Agenda
City of Springboro Planning Commission Meeting
Wednesday, September 13, 2023, 6:00 p.m.
Council Chambers, City Building, 320 West Central Avenue

Background Information & Staff Comments/Recommendations
City of Springboro Planning Commission Meeting
Wednesday, September 13, 2023, 6:00 p.m.
Council Chambers, City Building, 320 West Central Avenue

Final Development Plan, Village Park PUD-MU, Planned Unit Development-Mixed Use, 748 Gardner Road, retail development

- D. Preliminary Review, Rezoning, R-1, Estate-Type Residential District, to PUD-R, Planned Unit Development-Residential, 1525 South Main Street (SR 741), proposed single-family residential subdivision**
- E. Preliminary Review, General Plan, R-1, Estate-Type Residential District, to PUD-R, Planned Unit Development-Residential, 1525 South Main Street (SR 741), proposed single-family residential subdivision**

UTILITY PLAN

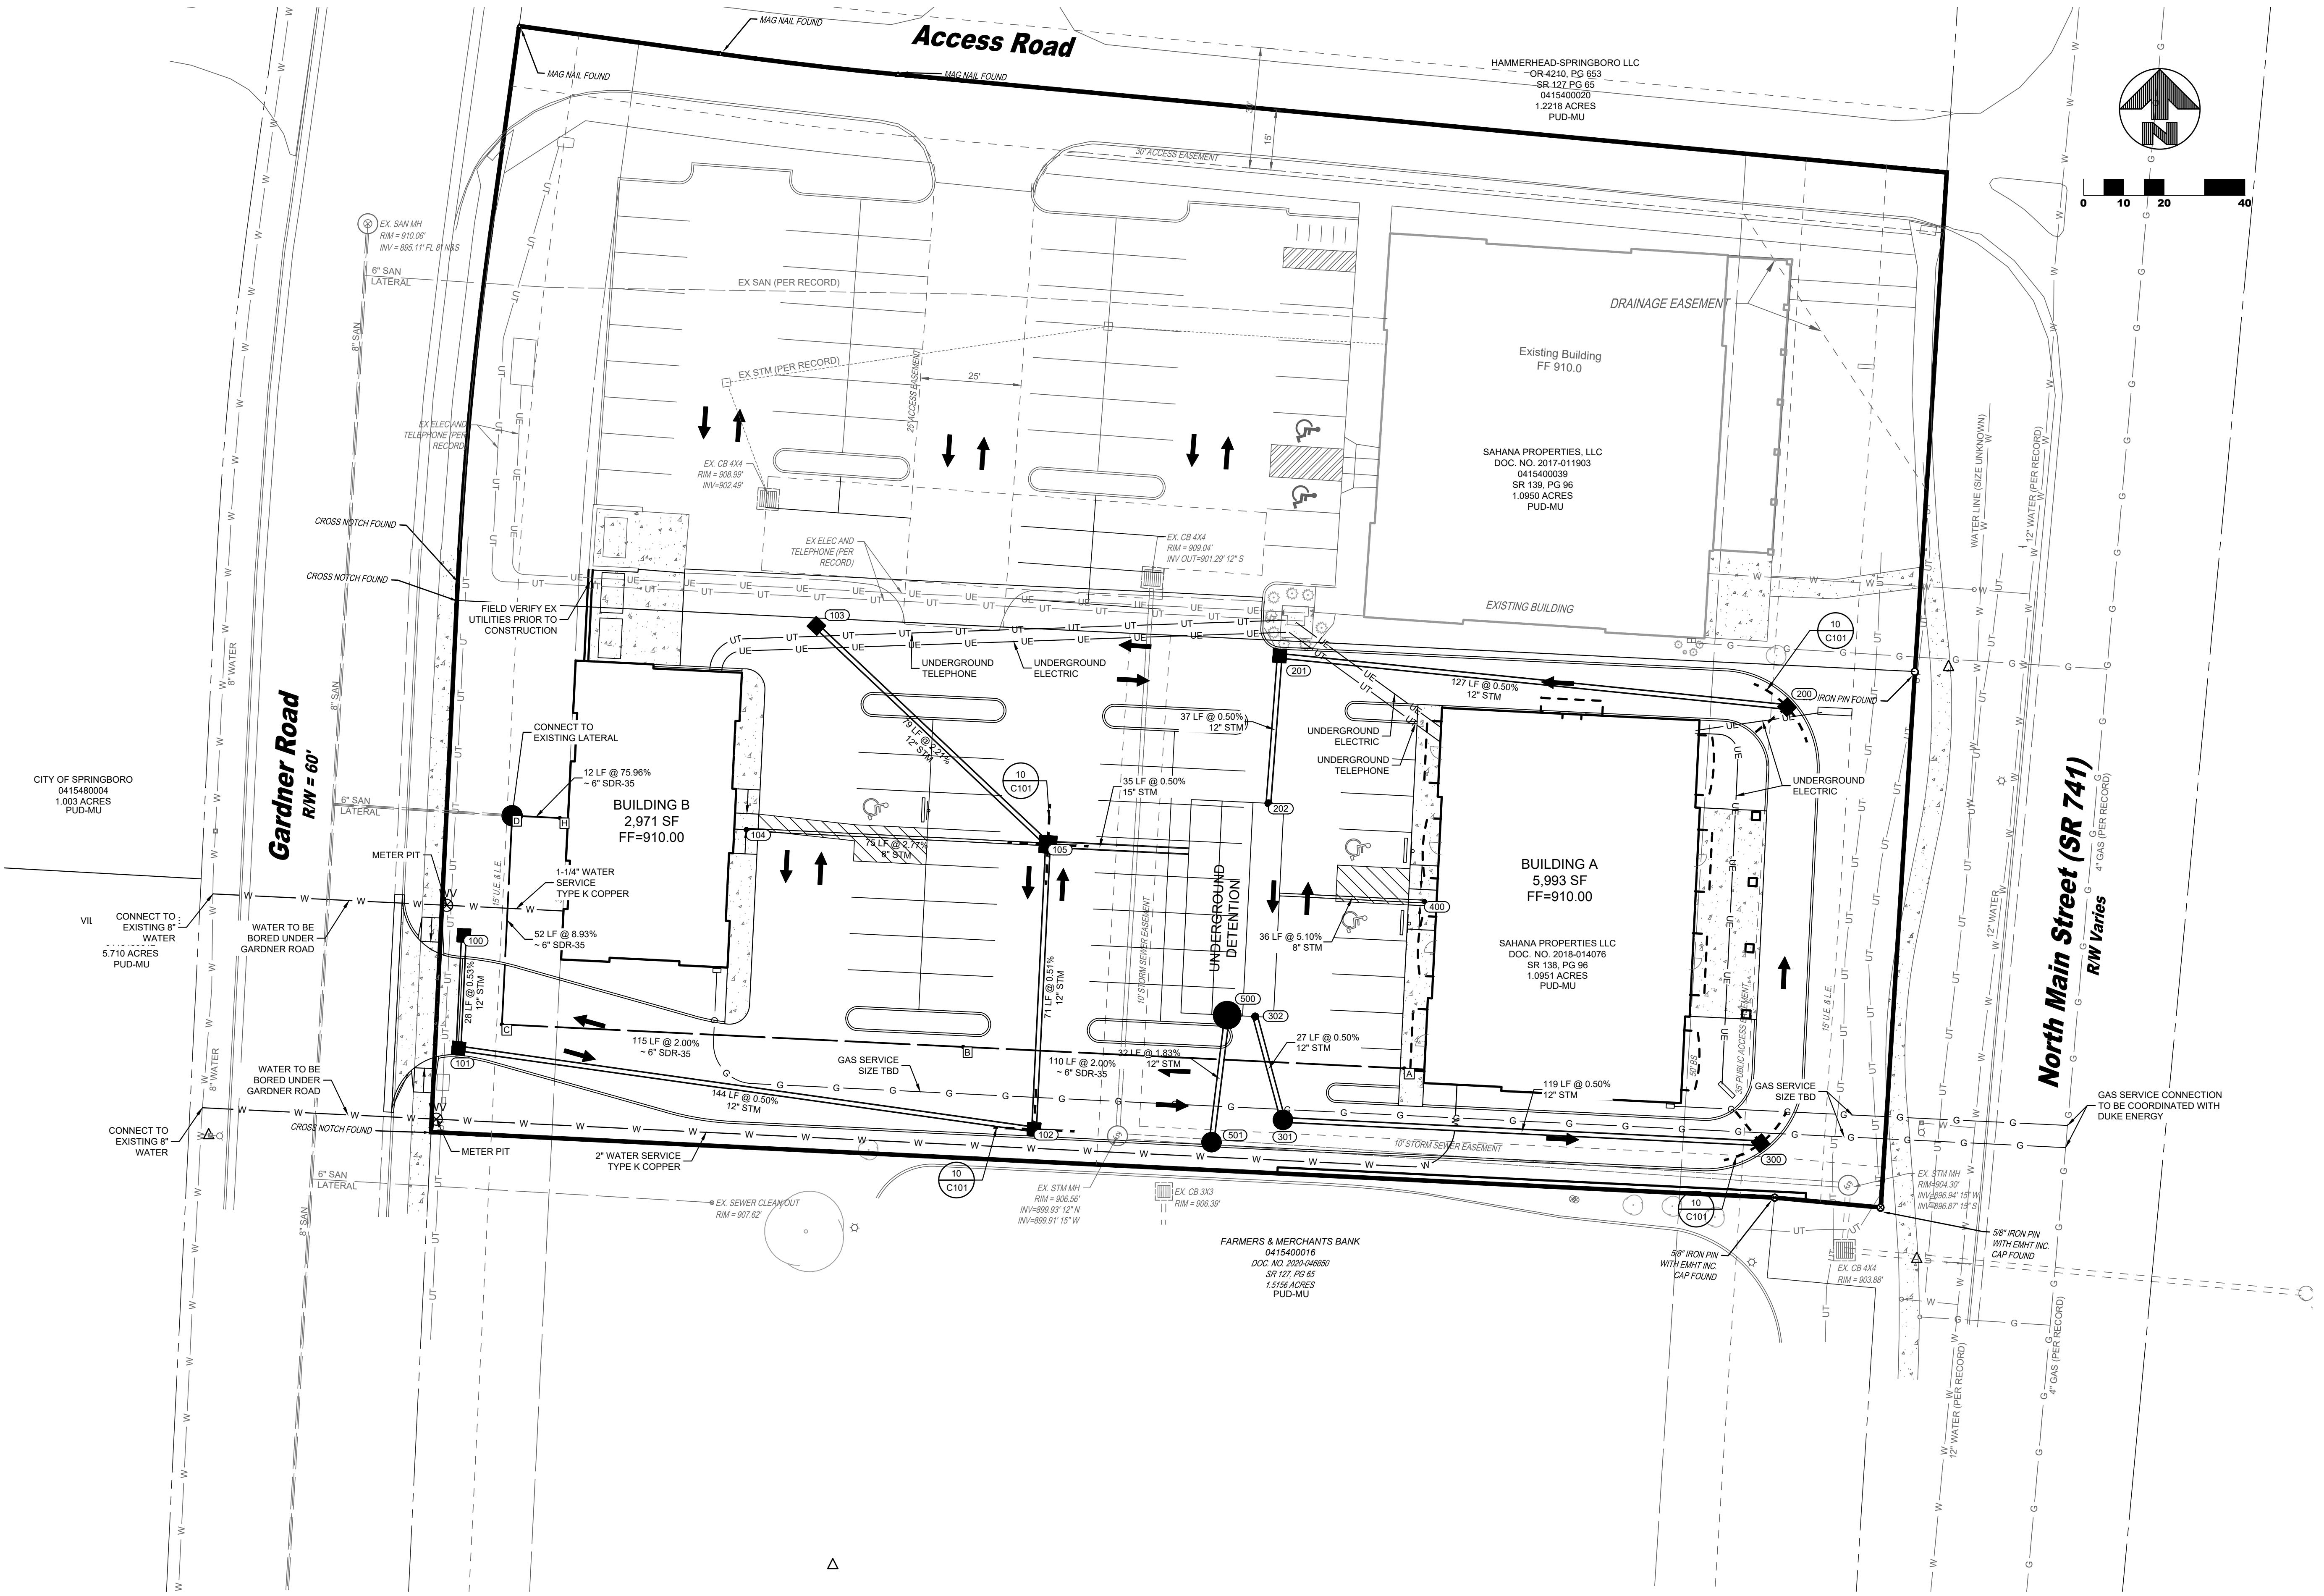
8. Provide separate 6" sanitary sewer lateral taps for each building tying directly into the existing 8" sewer main on Gardner Road. Minimum slope is 2%. Remove the proposed sanitary manhole in front of Building B, and connect to existing 6" sanitary lateral. Provide cleanouts every 100 feet and at bends. Provide details for the sewer tap on Gardner Road, such as saw cut and pavement replacement details.

9. Water meters to be located inside buildings – no meter pits. Also provide remote readers (mtu) for each service.
10. Provide curb stop for each water service lateral on the west side of Gardner Road in the tree lawn. The 2" water service lateral to be HDPE (250 PSI), SDR 9 material, with blue #14 minimum tracer wire.

11. Match crowns for storm sewer at manhole #301.
12. Provide invert information for catch basin #200.
13. Provide dumpster enclosure details.

14. State storm manhole #501 to be dog house manhole, and show existing 15" storm pipe elevations. If possible, connect this storm sewer span into the existing manhole, just west of MH #501.
15. Relocate proposed curb line, along south of lot, to be off of the existing storm manhole and proposed storm manhole #501.
16. Add note stating that any curb/sidewalk damaged during the water taps to existing main will be replaced per city specifications.
17. Consolidate the two lots into one.
18. Provide detention calculations for review.
19. Provide detailed plans for underground storage structure.
20. Provide an "AS BUILT" drawing showing as built location and elevations of all improvements, which shall be submitted prior to the issuance of an occupancy permit.
21. The Clearcreek Fire District has no comments at this time.
